RECEIPT DATE: 10-17-14 **ONSITE SEWAGE DISPOSAL SYSTEM** P 555275

PROPERTY ADDRESS: 13006 High Grove Road

RE: 13006 Highgrove Road  
BAT Plan and Building Plan

**SCHOOLEY MILL FARM**  
**SITE PLAN FOR BAT INSTALLATION**  
**FOR LOT 11**  
 13006 HIGHGROVE ROAD  
 Zoned: RR-DEO  
 Tax Map No. 40; Grid No. 10 & 11; Parcel No. 115 & 149  
 Fifth Election District - Howard County, Maryland  
 Date: AUGUST 25, 2014 Scale: As Shown

**PERMIT PLAN  
LOT 11  
SCHOOLEY MILL FARM**

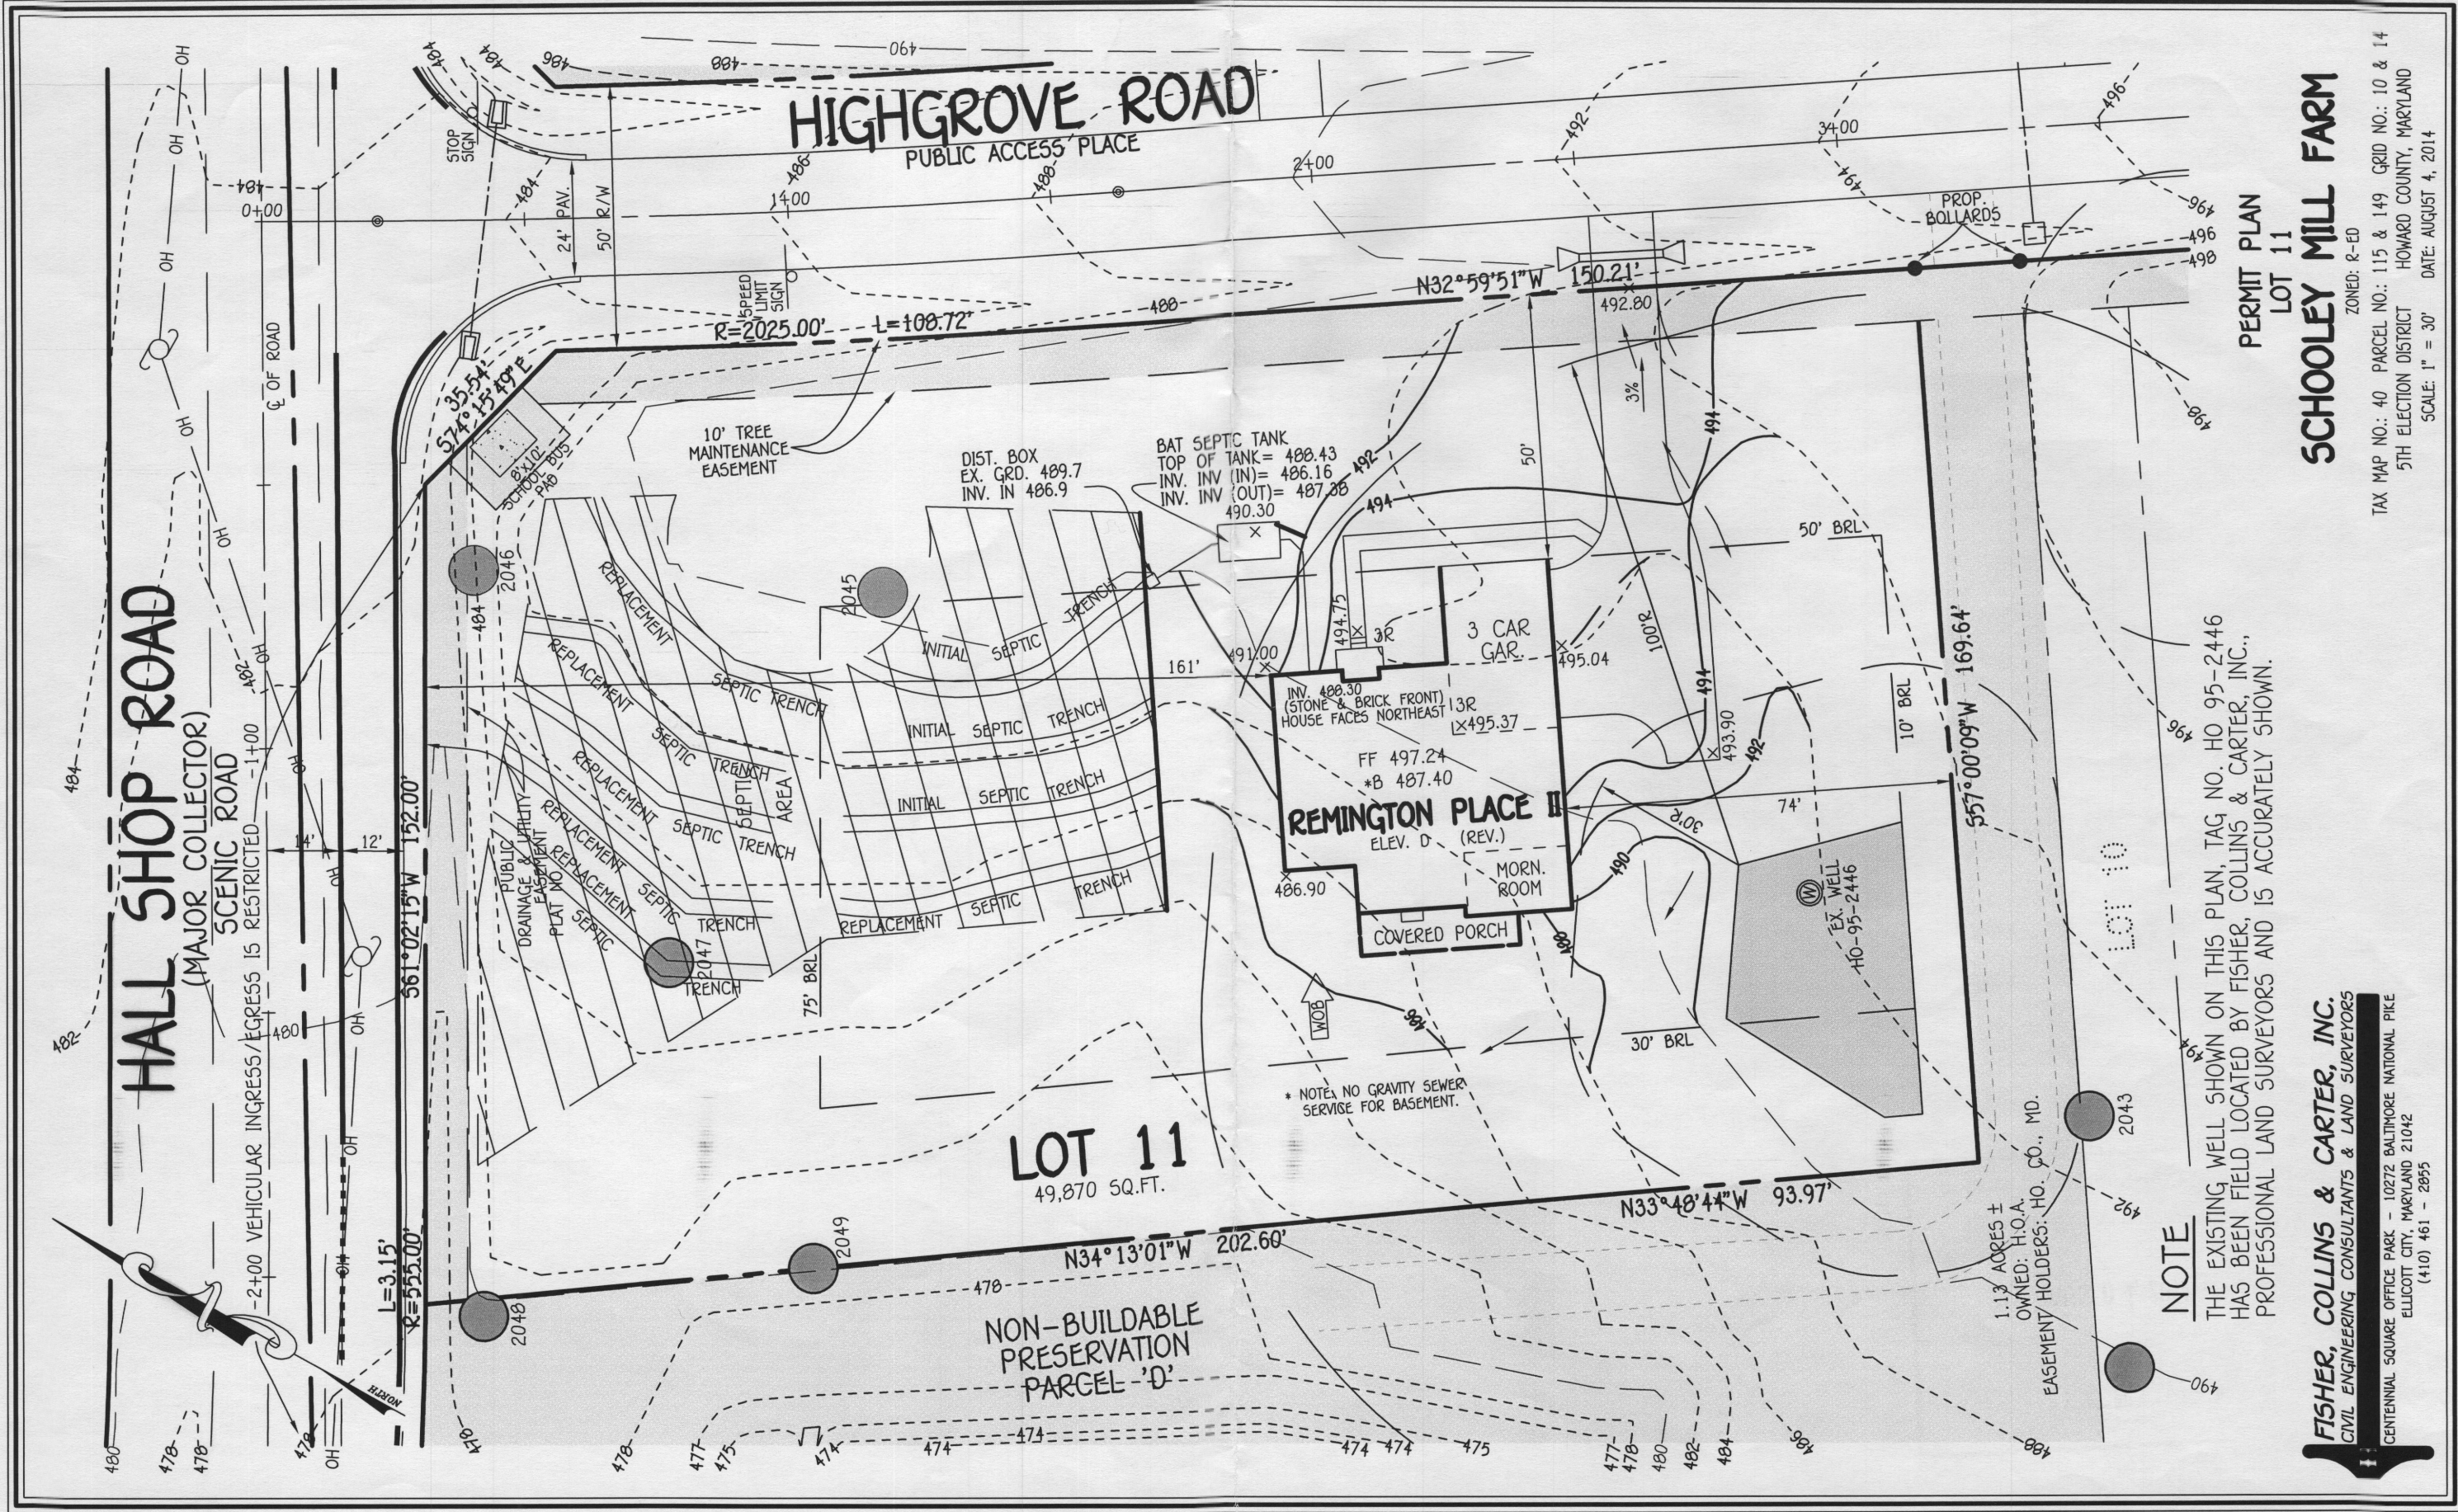
- Show the location of the initial absorption system and 2 replacements with perforated pipe elevations. All trenches should be equal in length and on contour. When redesigning your trenches try your inlet at 3 and 5 for your bottom, with your trenches 3 feet wide. The result will be a smaller trench length and less stone needed for your septic system design. And will result in a cost savings for the customer and have more room for your initial system and 2 replacements.
- I have included a copy of the BAT site plan requirements to use for your revisions. And a copy of the septic spec worksheet.

- Your building site plan must show the location of the initial absorption system and 2 replacements with perforated pipe elevations. All trenches should be equal in length.

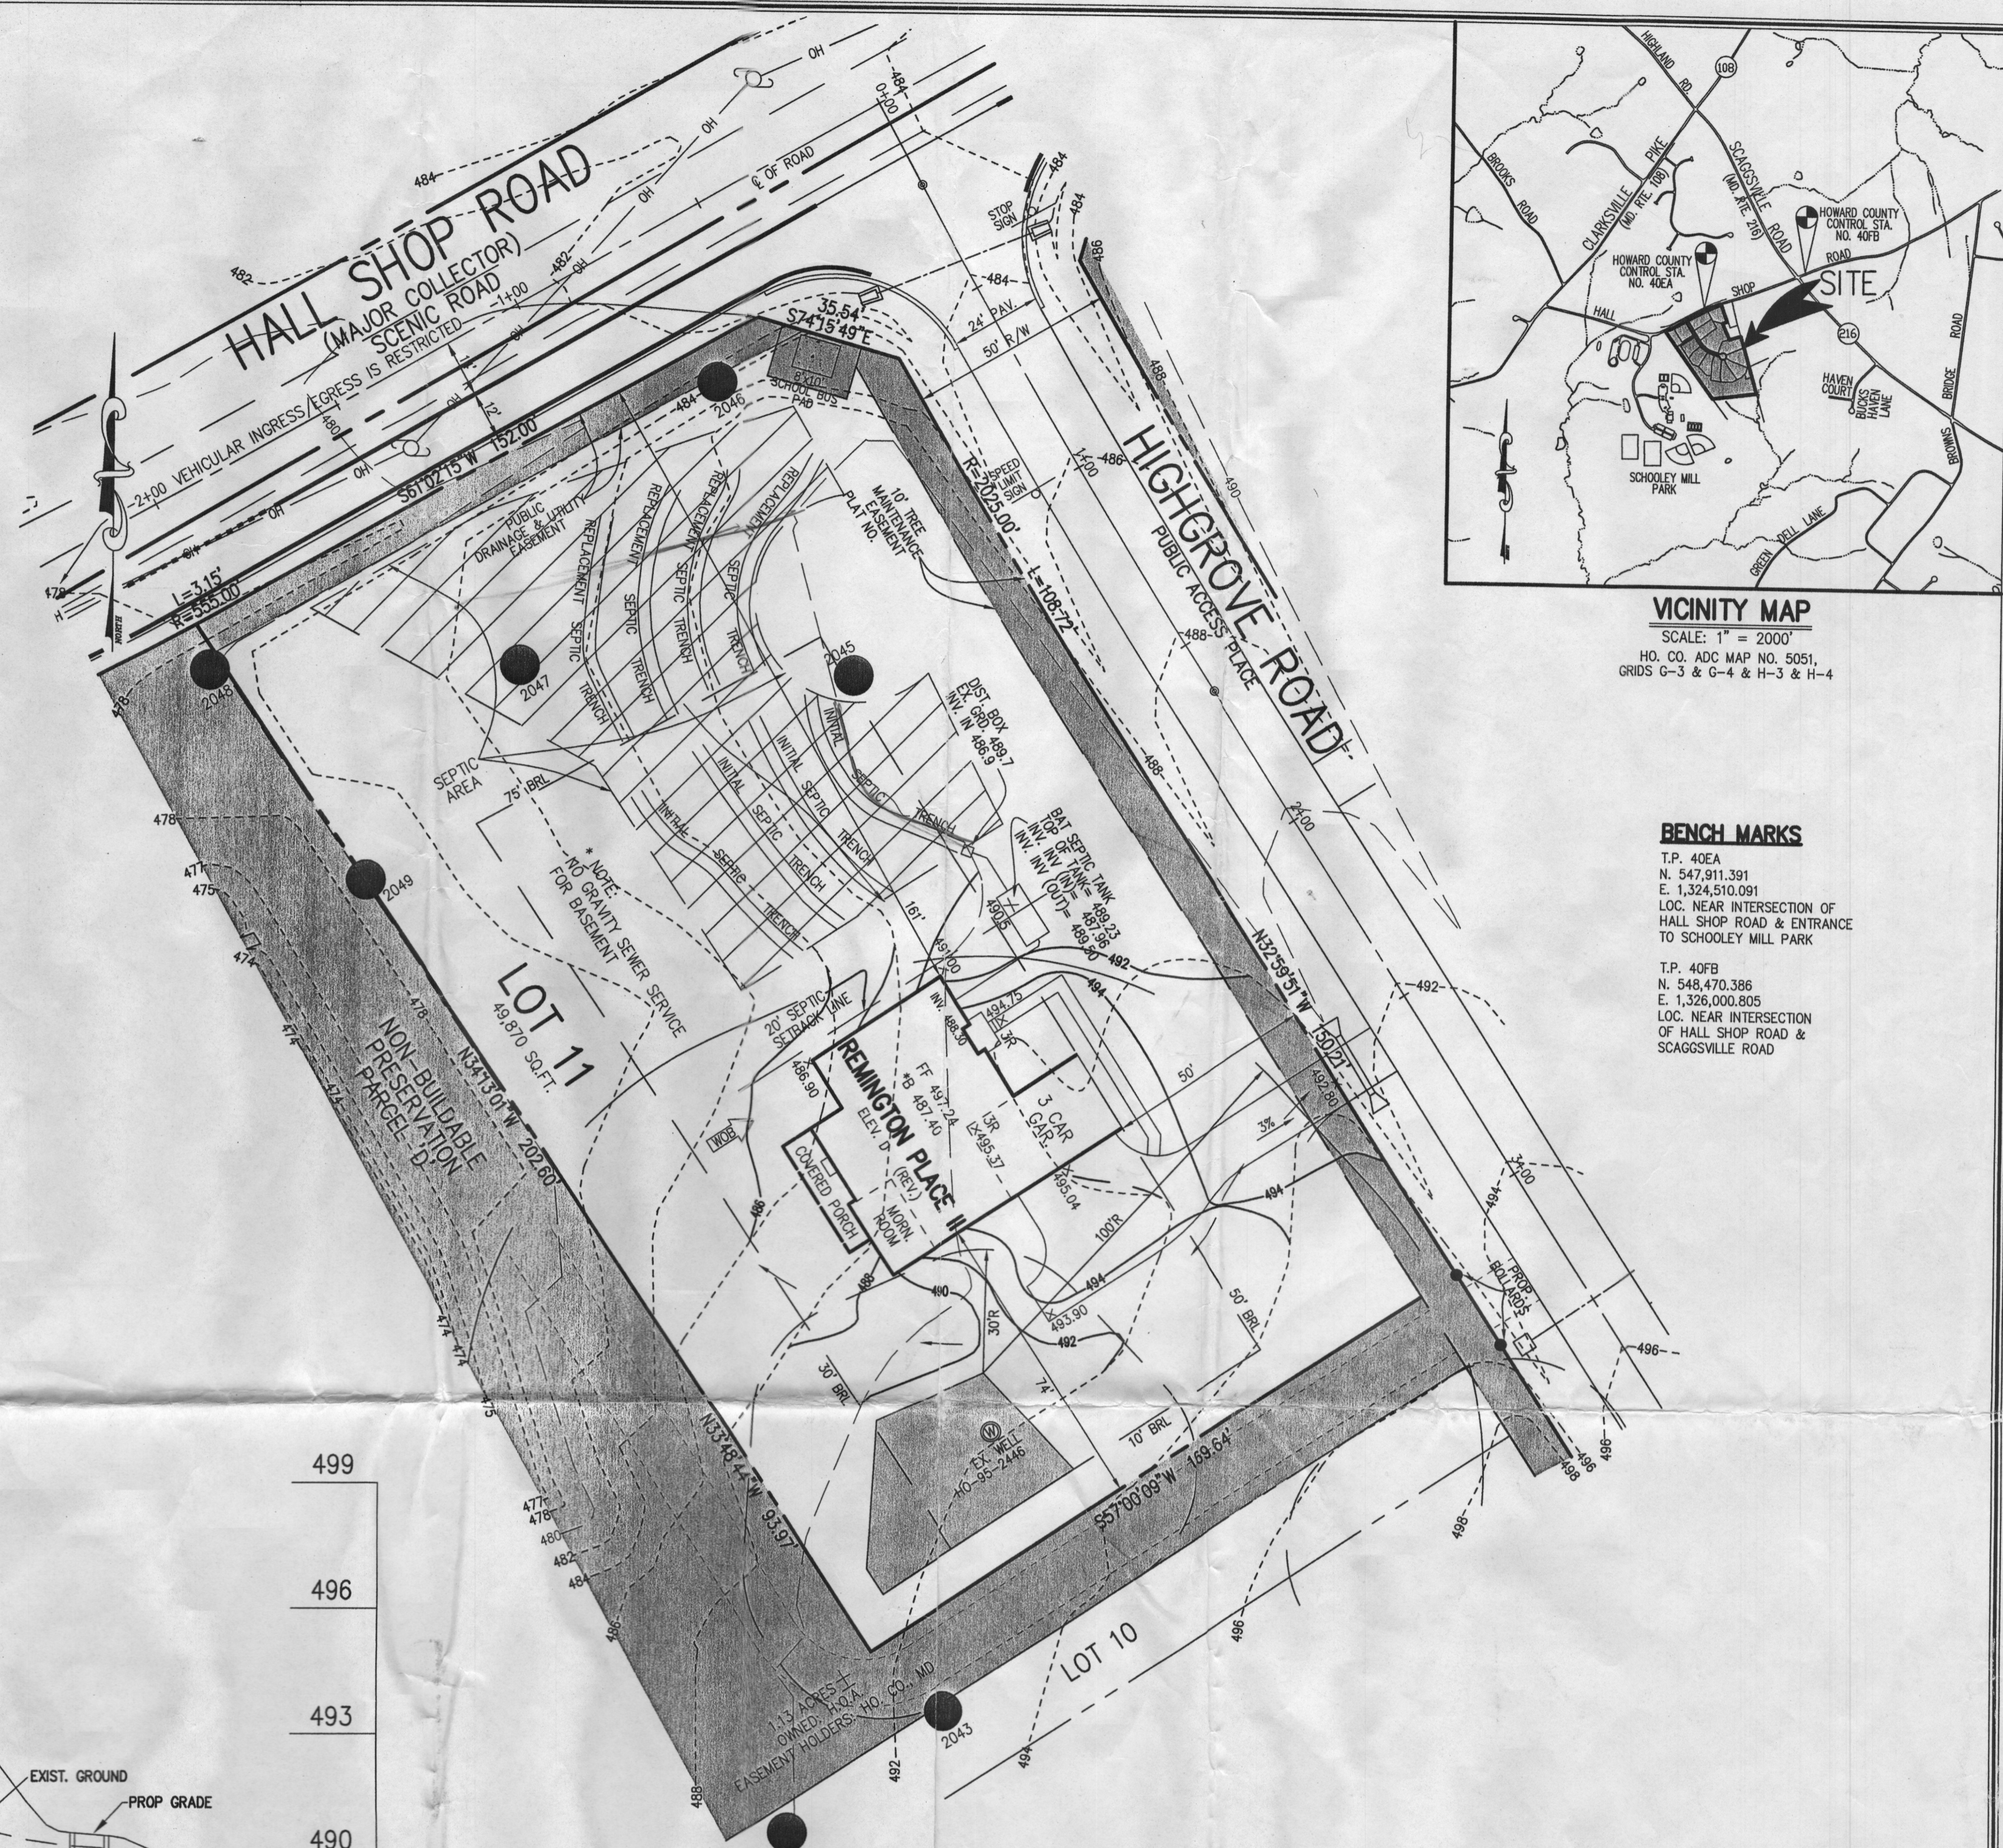
I looked at lot 3 and went back to see what I approved on the lot 11 revision. I made a concession on lot 11 and also missed something that has since come to my attention. The concession was that there is no note stating "the manufacturer has certified the proposed BAT unit is capable of handling the flow for the proposed 6 bedroom house."

The missed item is that the Hoot unit was deemed in compliance with the emergency storage requirements of our local code and COMAR by calculating the capacity above the high water probe in the 3<sup>rd</sup> chamber and also the air space above the liquid level in the whole tank up to the lid. That total space is 790 gallons, which is adequate for up to 5 bedrooms. A 6 bedroom home has a design flow of 900 gallons. A pumped system for a 6 bedroom home must provide 900 gallons of emergency storage above the high water alarm within the tank.

We have approved the building permits for these lots, but before we can issue the septic permits, we will need a revised plan showing a new tank design that can accommodate 900 gallons of emergency storage. Thanks  
Jeff
